**CITY OF
PARRAMATTA**

Submission

To the Department of Planning, Industry
and Environment

In response to the public exhibition
of the 2020 revised draft master
plan for the Carter Street
Precinct

Figure 3 – Figure 43 of the UDR with updated pedestrian and cycling connections

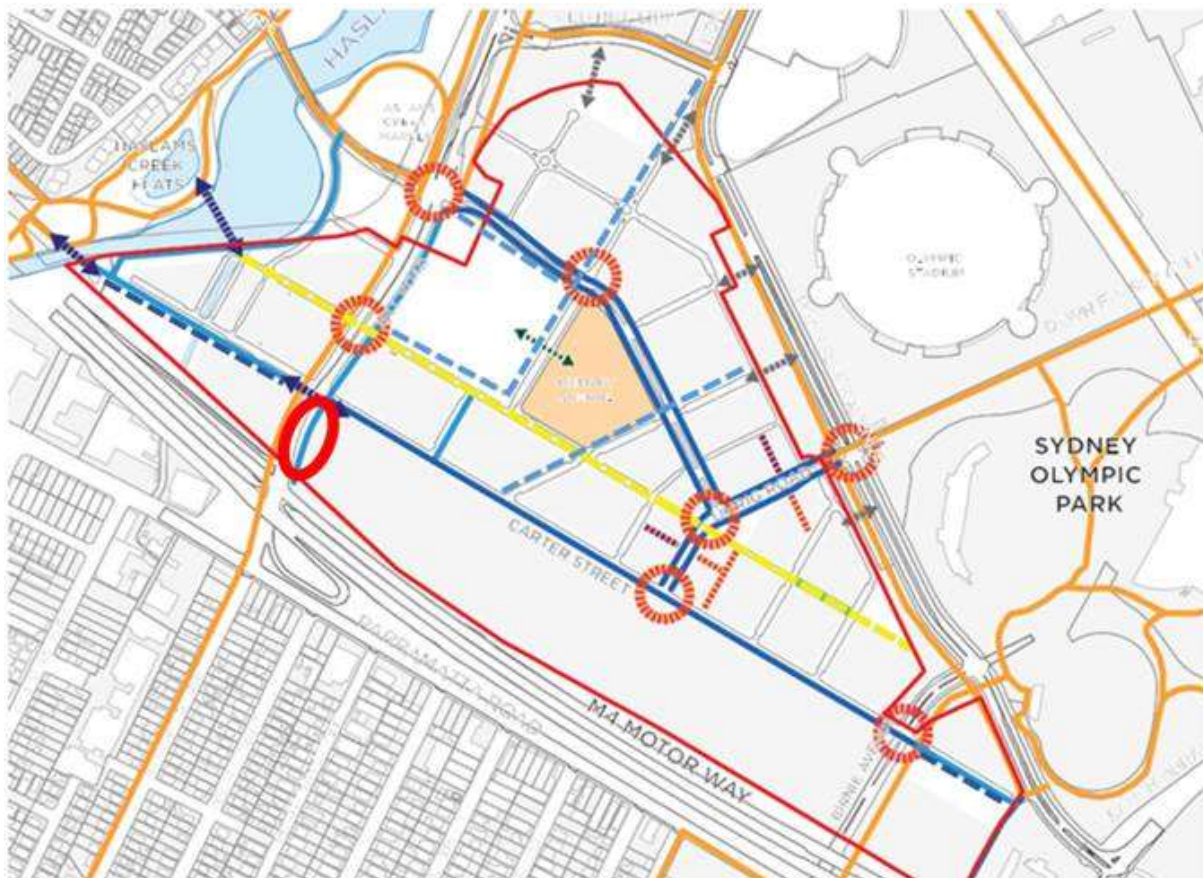
17. Section 6.7 of the UDR, Figure 43 is missing a number of proposed pedestrian and cycling connections.

Furthermore, the path on the eastern side of Hills Road between the M4 and Carter Street is not supported as the on-ramp G-loop prevent access further south to Parramatta Road (outlined in red).

Recommendation - Figure 3 has the following pedestrian and cycling connections added as dashes and are recommended to be included in the CSMP:

- Shared user path on all sides of Central Public Open Space;
- Shared user path on western side of Road #7 and Road #9;
- Shared user path on western side of Road #6 and Road #5;
- Separated bicycle path southern side of Carter Street extension both west of Hill Road and east of Birnie Avenue.

Figure 4 Street Section [A-A – Green Spine](#)

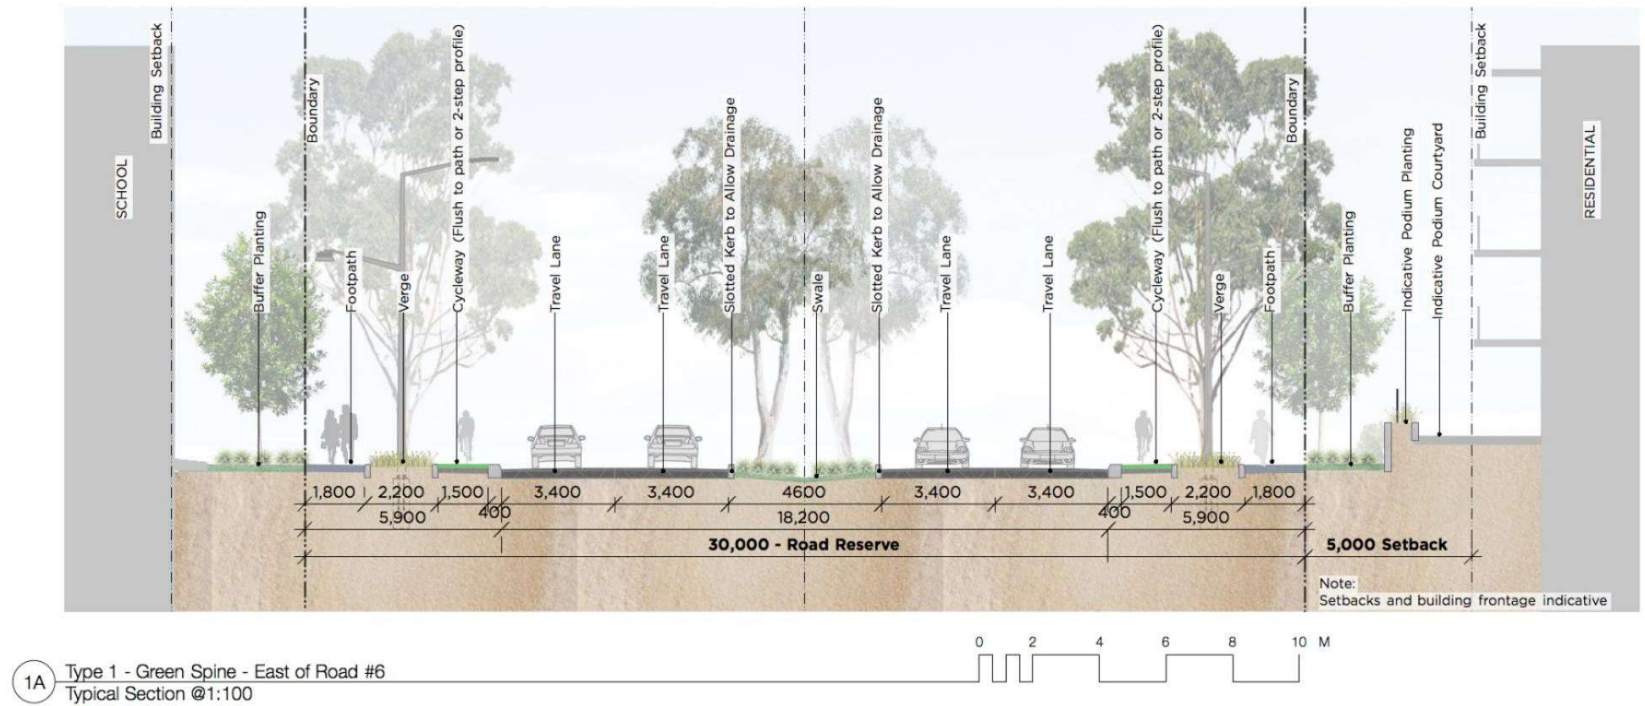
[Show a public street frontage to Haslams Creek.](#)
[Show street connections into the SOP street network.](#)

Note
[Street sections are to be updated in accordance with comments provided on the Master Plan](#)
[On street car parking is required.](#)

Figure 5: Street Section B-B – Uhrig Road North

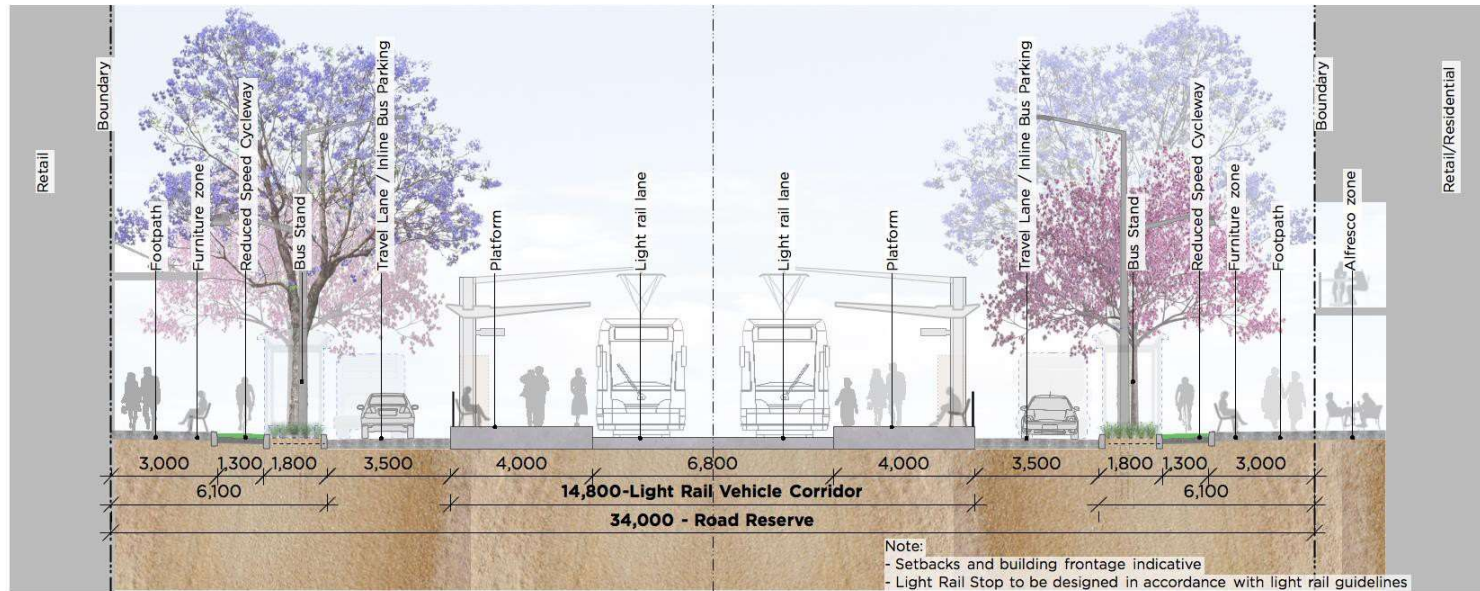
Building colonnades are not supported.

Figure 6 Street Section **C-C – Uhrig Road South**

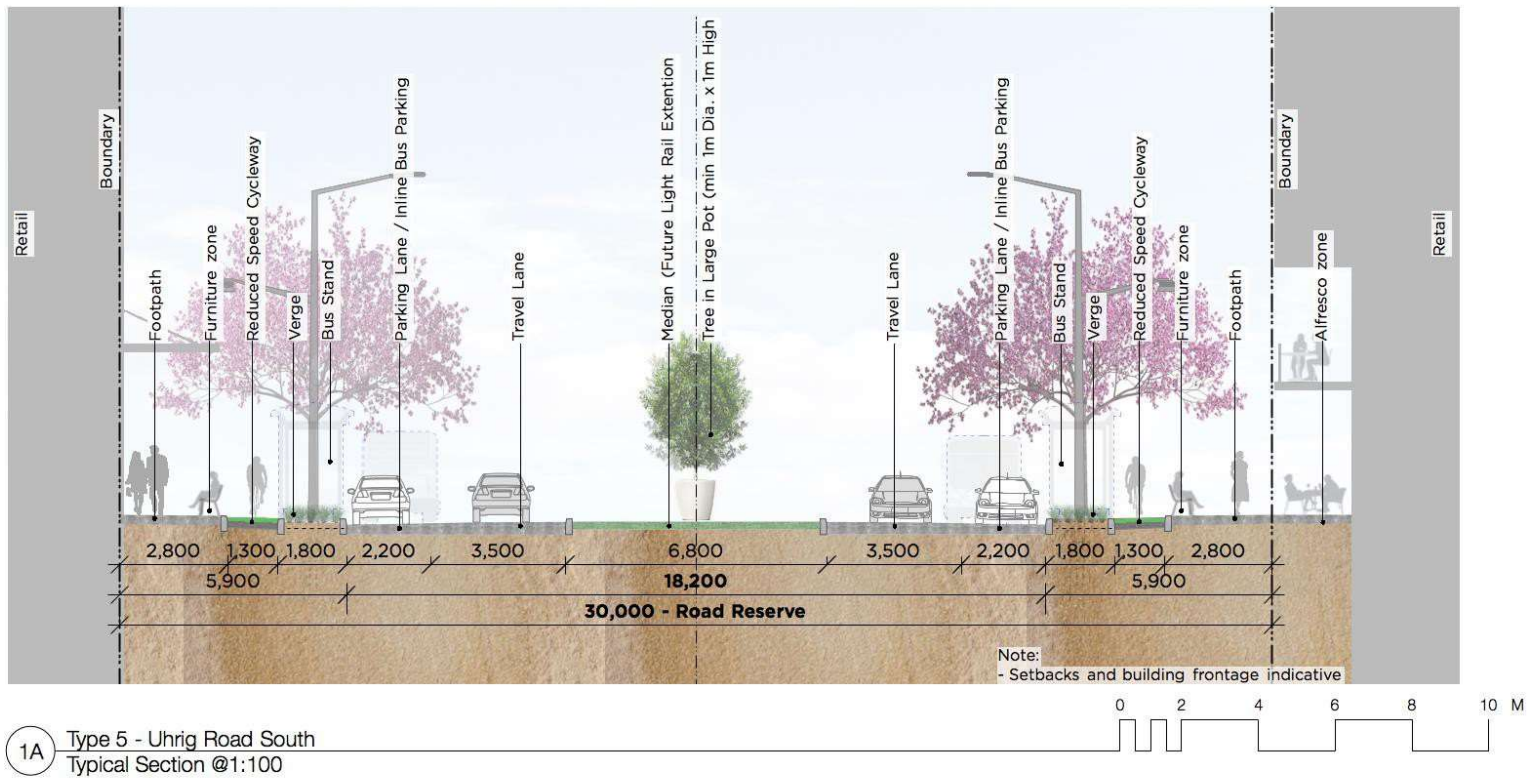
Clearly show 1.8m clear path of travel and any proposed outdoor dining zone separate to cycle way.
No building colonnades.

Figure 9 – Street Section F-F – Local Street

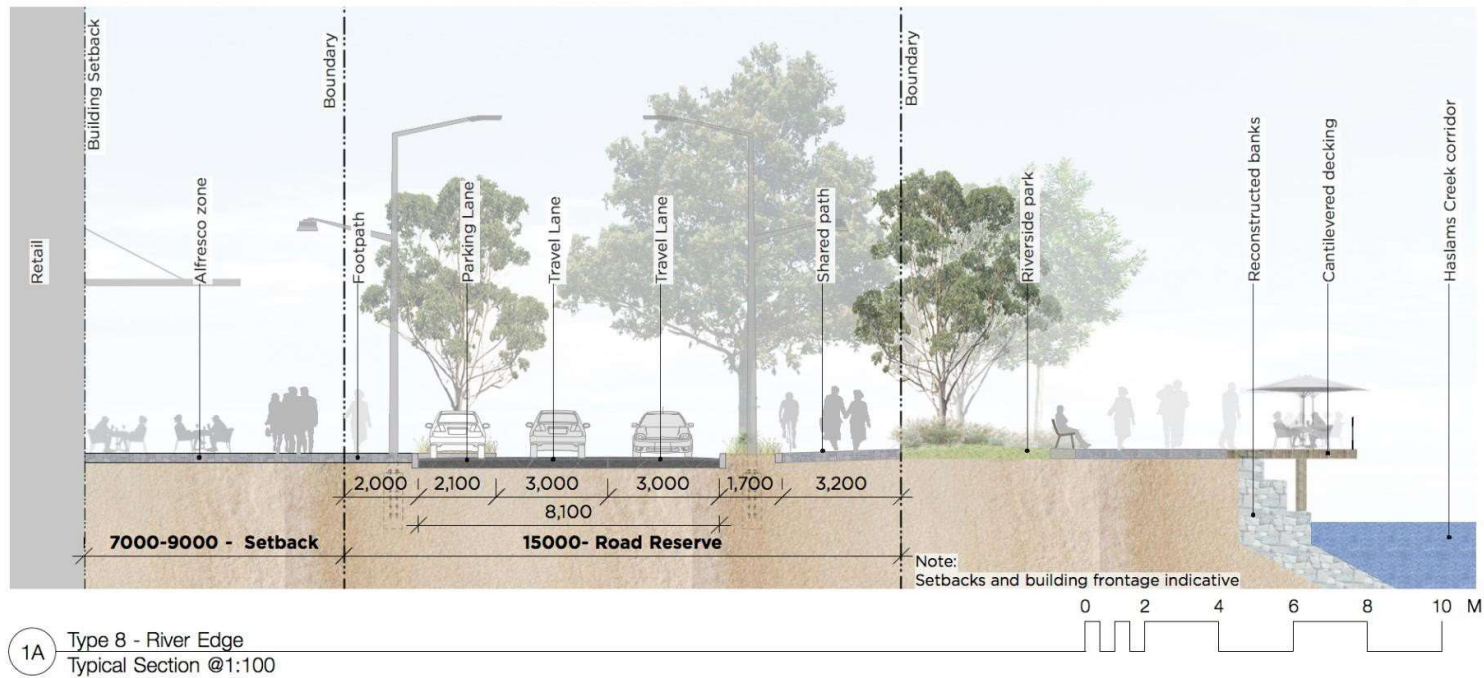
***the shared path width of 3.2m is considered too narrow as a link towards Newington. Consider Shared path width of 4m**

Figure 10: Street Section G-G Local Road – Park Edge

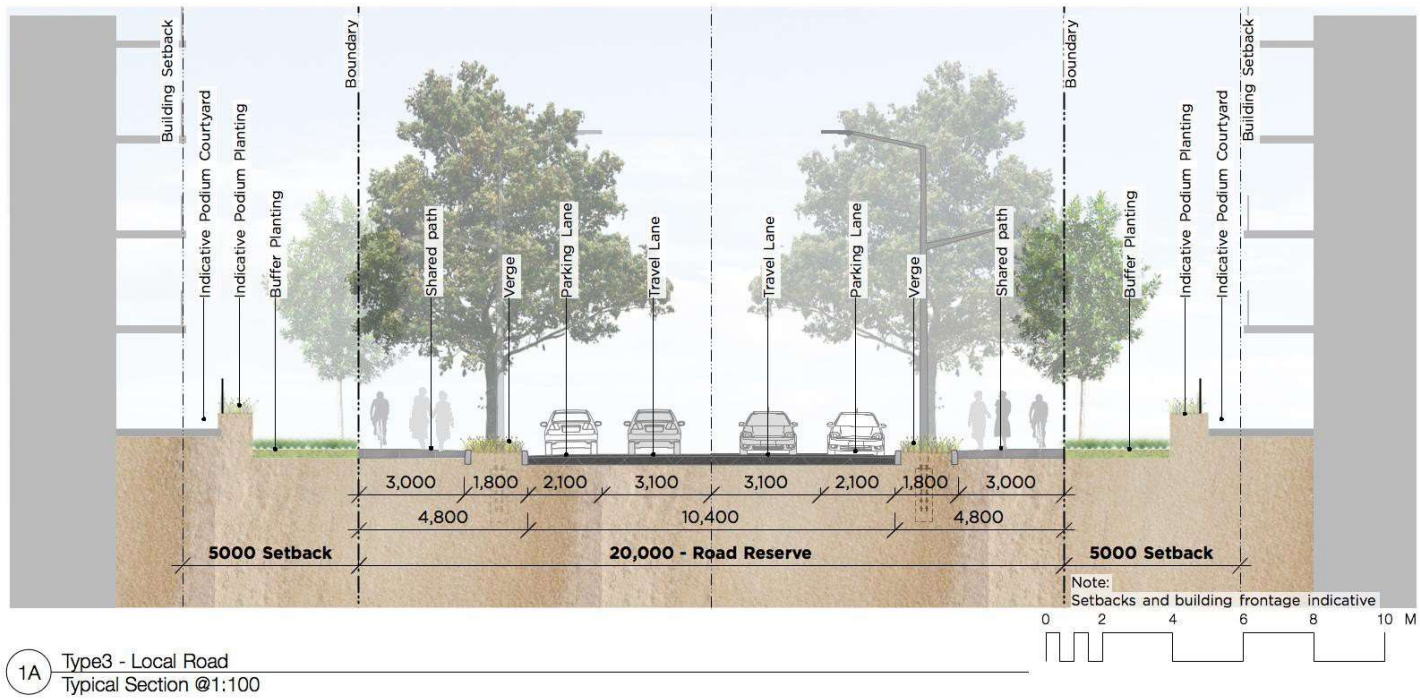
Show minimum 5m ground floor building setback on the drawing.

*** the shared path width of 3.2m on park side is considered too narrow as the main shared path around the main recreation park. Consider Shared park width of 4m.**

Figure 11: Street Section H-H – Carter Street

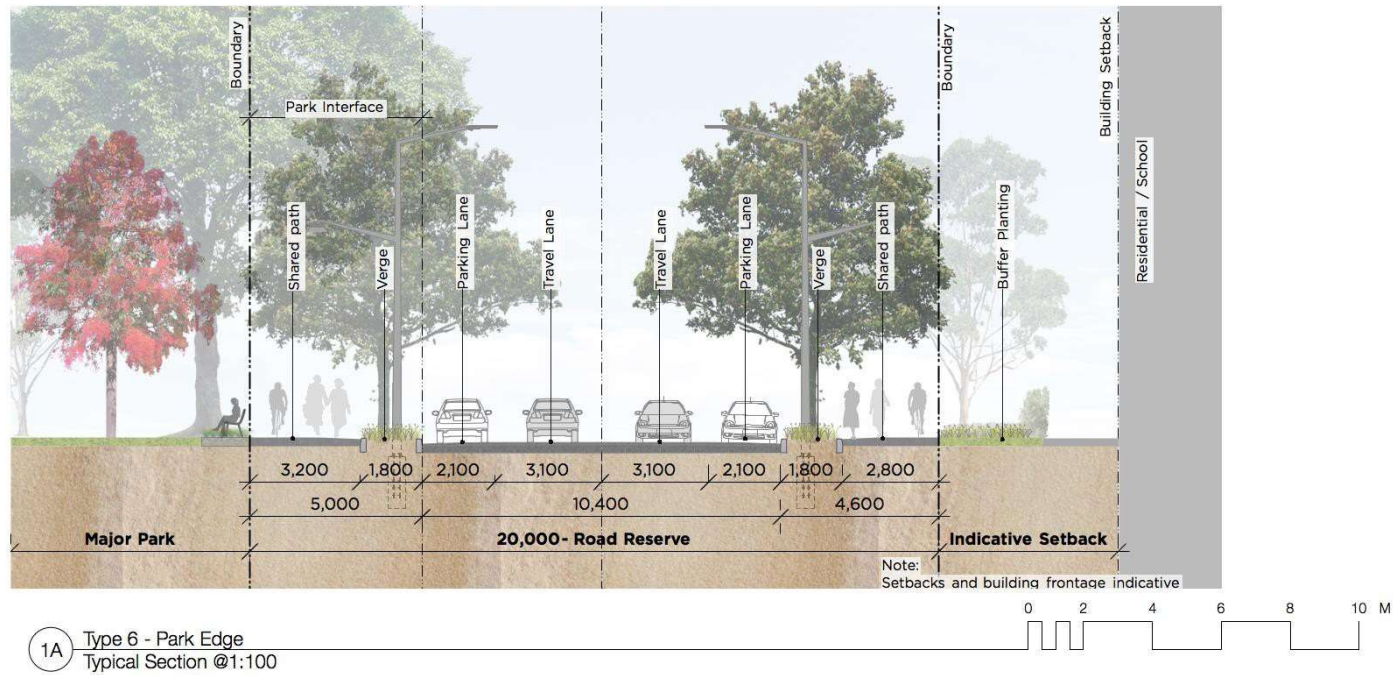
* The shared path width of 3.2m on park side is considered too narrow as the main shared path around the main recreation park. Consider shared path width of 4m.

* the shared path width of 2.5m is considered too narrow as the regional cycleway link along Carter Street. Consider Sshared path width of 3m

Figure 13: Street Section J-J – Canal Street

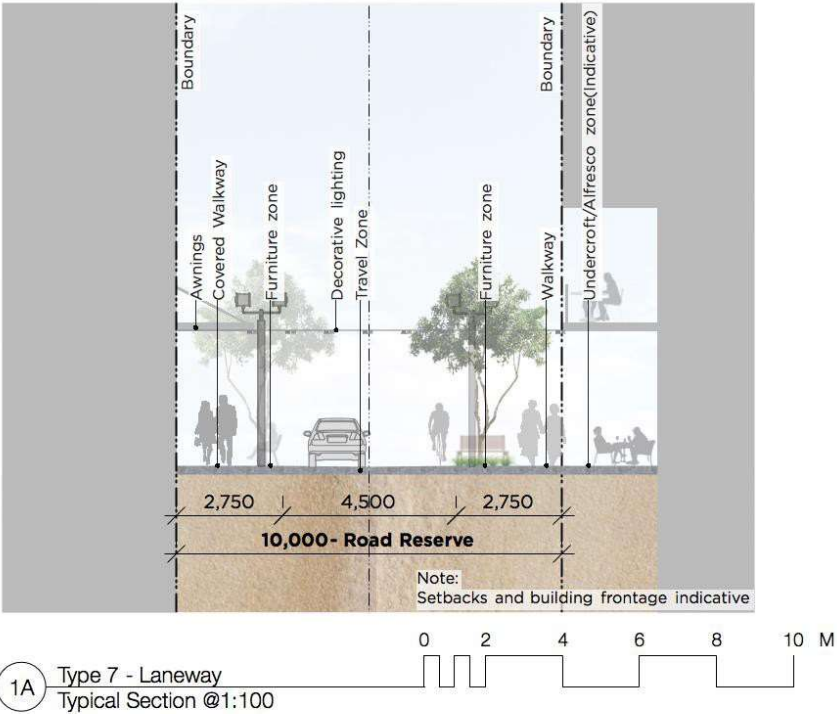
Demonstrate that ADG building separation requirements are met.

*** No shared path or off-road cycle facility shown. Consider making one side a 3m wide shared path**

Figure 17: Public open space network

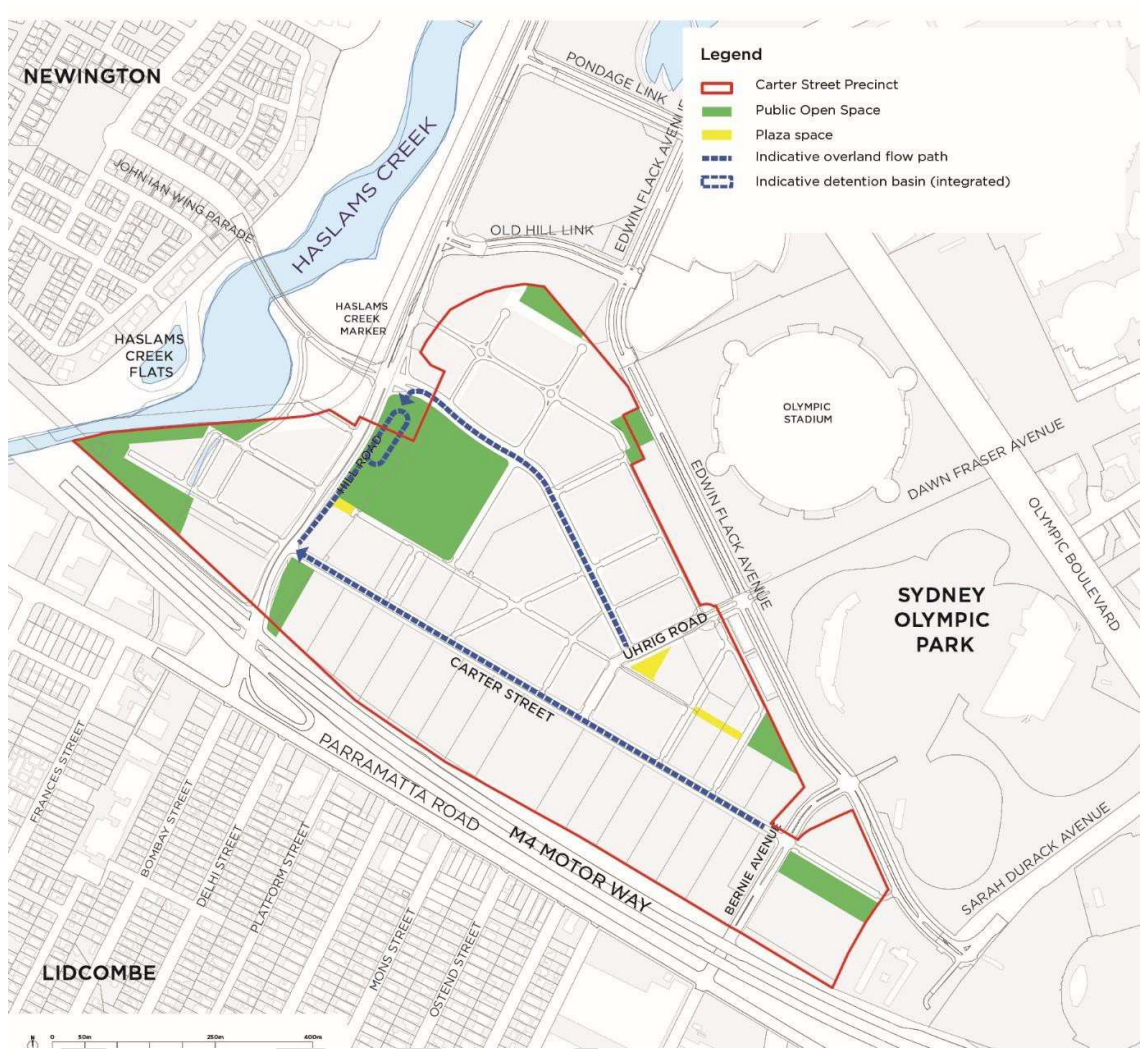
[Review the master plan configuration in the western corner abutting Haslam's Creek – refer master plan commentary.](#)

Figure 18: Indicative Haslams Creek foreshore (subject to discussions with Sydney Water)

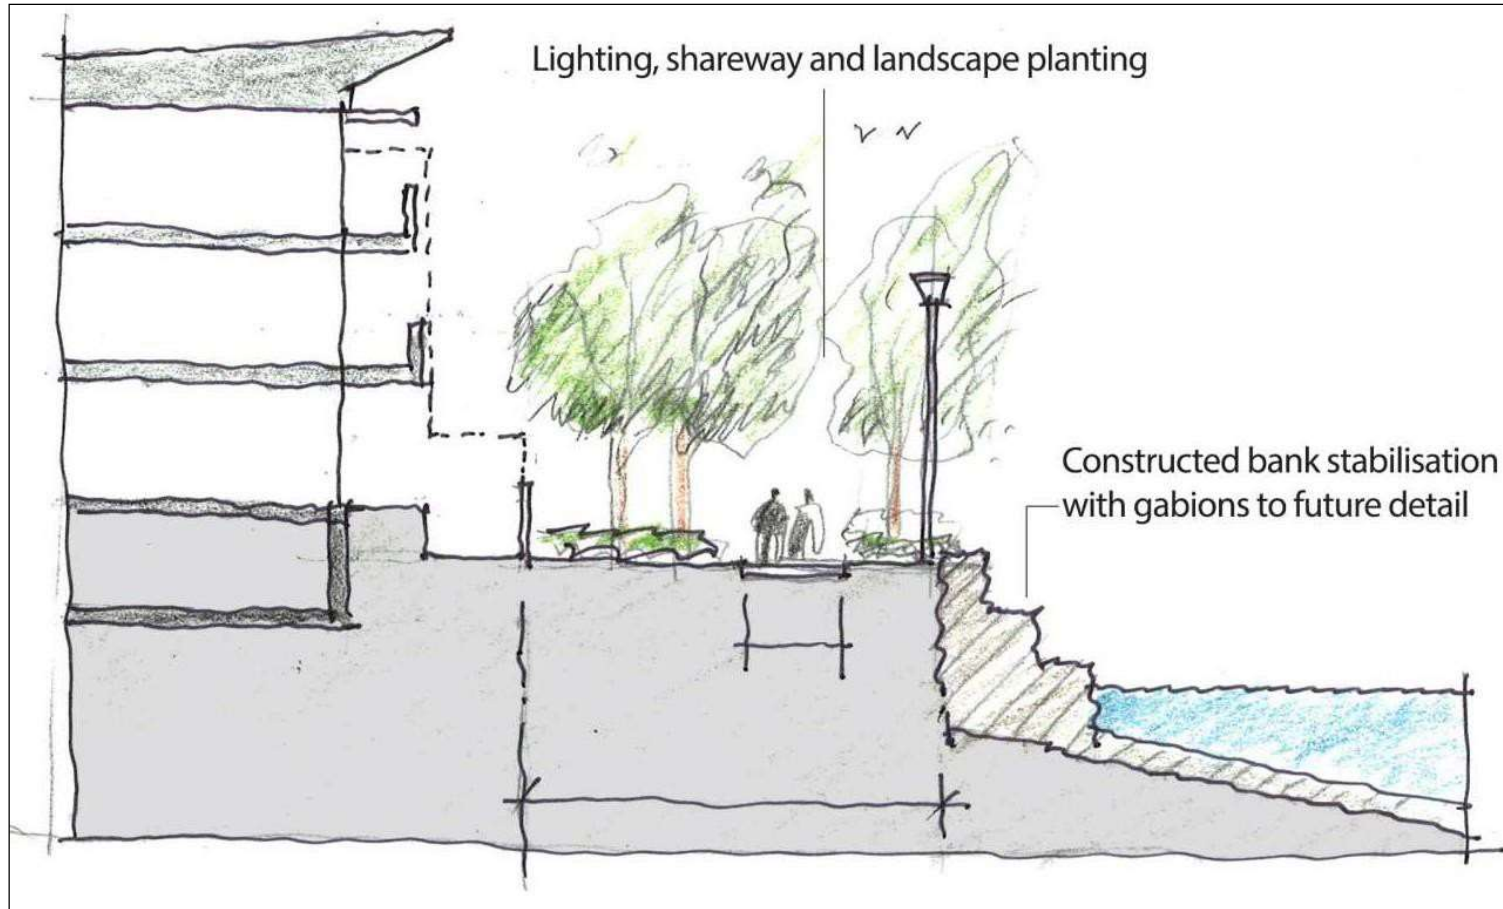
Note – a public street is required fronting Haslam's Creek.
